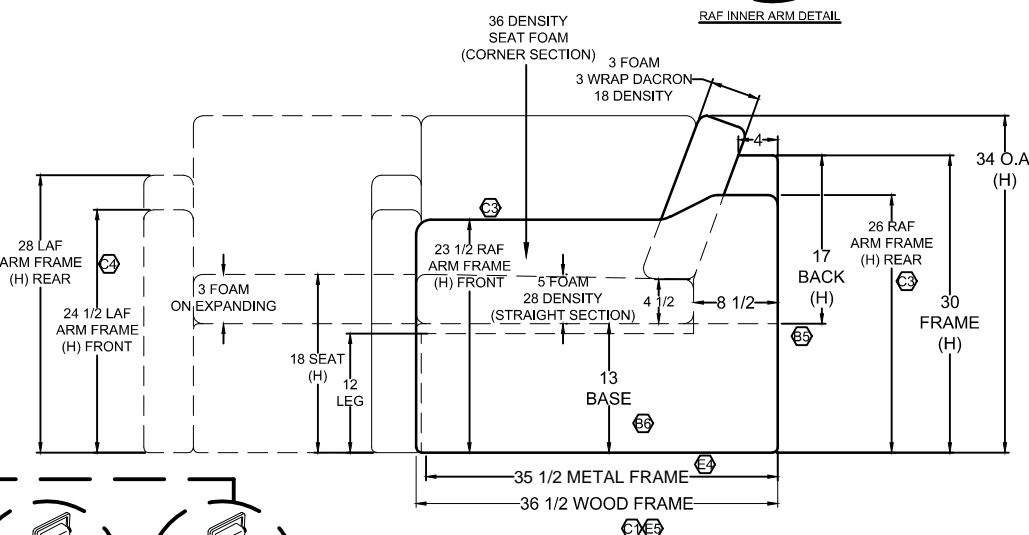
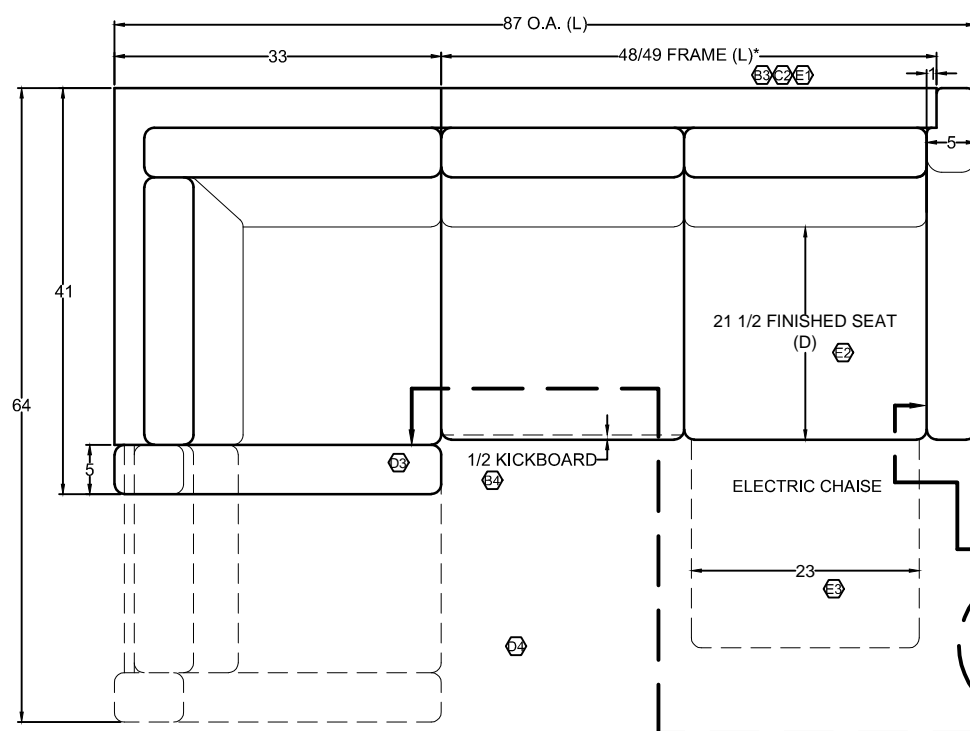
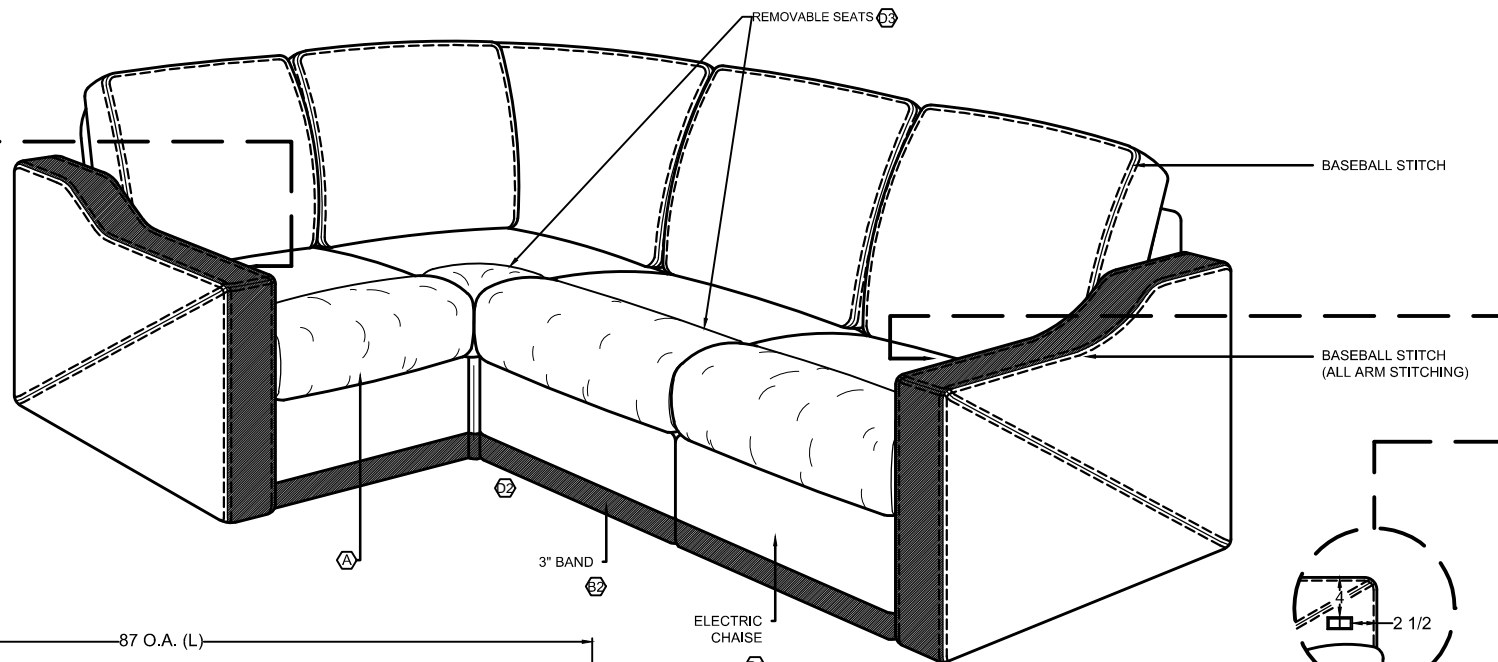
LB	E	PRODUCTION UPDATE: [1] CHANGED BACK FRAME LENGTH TO 48/49"; WAS 49". [2] CHANGED FINISHED SEAT DEPTH TO 21 1/2"; WAS 22". [3] CHANGED WOOD FRAME WIDTH TO 23"; WAS 23 1/4". [4] ADDED METAL FRAME DEPTH DIMENSION. [5] ADDED WOOD FRAME DEPTH DIMENSION.	05.30.19
FP	D	PRODUCTION UPDATE: [1] ADDED SWITCH TO INNER ARM; [2] REMOVED CSA; [3] ADDED REMOVABLE SEATS; [4] REMOVED RECLINER SWITCH; [5] CHANGED LOCATION OF EXPANDING SWITCH.	11.30.18
JA	C	PER RL PRODUCTION: [1] CHANGED O.A. DEPTH TO 38-1/2"; WAS 35-1/2". [2] CHANGED FRAME WIDTH TO 49"; WAS 50". [3] UPDATED RAF ARM FRAME HEIGHTS TO 23-1/2" FRONT & 26" REAR. [4] ADDED LAF ARM FRAME HEIGHTS OF 24-1/2" FRONT AND 28" REAR.	10.26.18
JA	B	[1] ADDED RAF ELECTRIC CHAISE. [2] REMOVED TOE KICK. [3] CHANGED FRAME WIDTH TO 50"; WAS 49". [4] CHANGED KICKBOARD TO 1/2"; WAS 2-1/2". [5] CHANGED BACK FRAME HEIGHT TO 17"; WAS 18". [6] ADDED 13" BASE HEIGHT DIMENSION TO DRAWING. (REF ORDER #0131646)	09.26.18

JA	A	PER RL. REMOVED CUSHION WRAP FROM SEATS.	02.19.18
